Subject: Code Case N-613

Subject: Proposed Revision to Code Case N-613, "Ultrasonic Examination of Full Penetration Nozzles, Examination Category B-D, Item No's. B3.10 and B3.90, Reactor Vessel-To-Nozzle Welds, Fig. IWB-2500-7(a), (b), and (c), Section XI, Division 1"

**Case N-613
Ultrasonic Examination of Full
Penetration Nozzles, Examination
Category B-D, Item No's. B3.10 and
B3.90, Reactor Vessel-To-Nozzle Welds,
Fig. IWB-2500-7(a), (b), and (c), Section
XI, Division 1**

**Case N-613-1
Ultrasonic Examination of Full
Penetration Nozzles, Examination
Category B-D, Item No's. B3.10 and
B3.90, Reactor Vessel-To-Nozzle Welds,
Fig. IWB-2500-7(a), (b), and (c), Section
XI, Division 1**

FIG. 1 NOZZLE IN SHELL OR HEAD
 (Examination Zones in Barrel Type Nozzles Joined by Full Penetration Corner Welds)

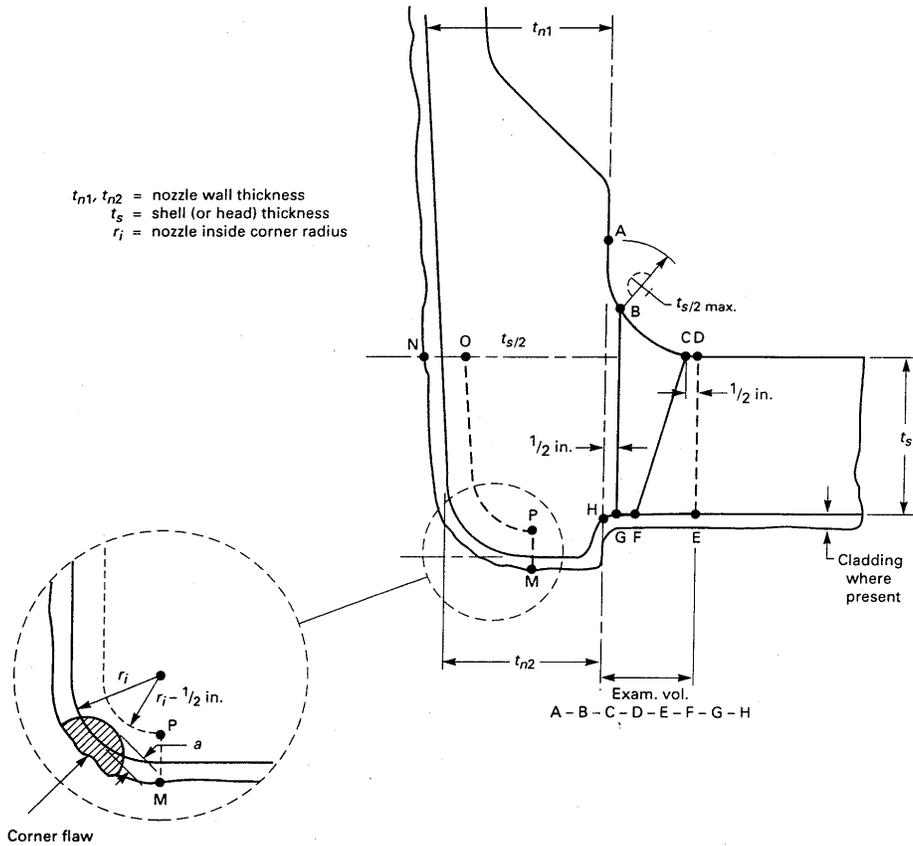
Example using UT from Rx inner surface:

50.55a(2)(xv)(k)(z)(i)
 inner 15% in 4 directions
 qualified to Supp 4 modified by
 50.55a(b)(2)(xv)(B) & (C)

IF SUCCESSFUL DO NO MORE UT.
 IF NOT THEN UT FROM NOZZLE
 BORE IAW 50.55a(b)(2)(xv)(k)(1)
 which refers to table VIII-57-1 Modified

50.55a(2)(xv)(k)(2)(i)(i)
 examine from nozzle bore per
 (k)(1)(i) or from vessel shell using
 single sided qualified IAW Supp 6
 as modified by rule.

Per table VIII-57-1

- a: Flaws parallel & perpendicular (perpendicular excluded by (b)(2)(xv)(k)(1)(i))
 - b: OD Parallel
 - Subsurface Parallel
- Exam. vol. A-B-C-D-E-F-G-H

Reply: It is the opinion of the Committee that ultrasonic examination of previously ultrasonically examined Category B-D nozzles, as diagramed in IWB-2500-7(a), (b), and (c), may be examined within the reduced examination volume (A-B-C-D-E-F-H) as diagramed in Figs. 1, 2, and 3.

FIG. 2 NOZZLE IN SHELL OR HEAD
 (Examination Zones in Flange Type Nozzles Joined by Full Penetration Butt Welds)

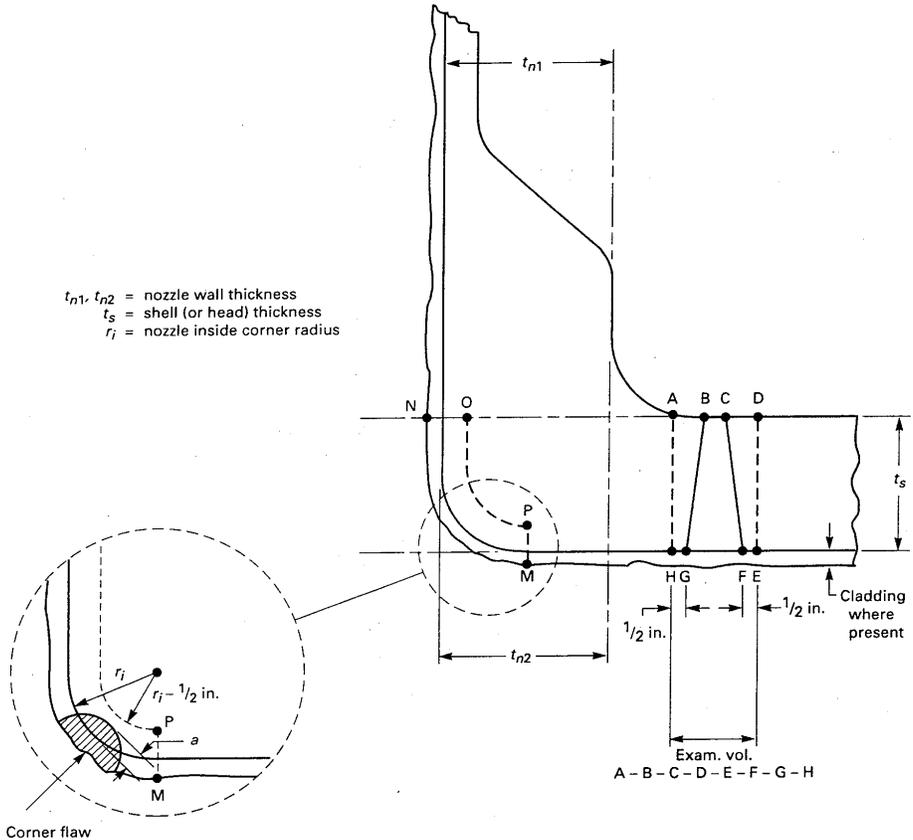
Figure Diagraming NRC Required Coverage
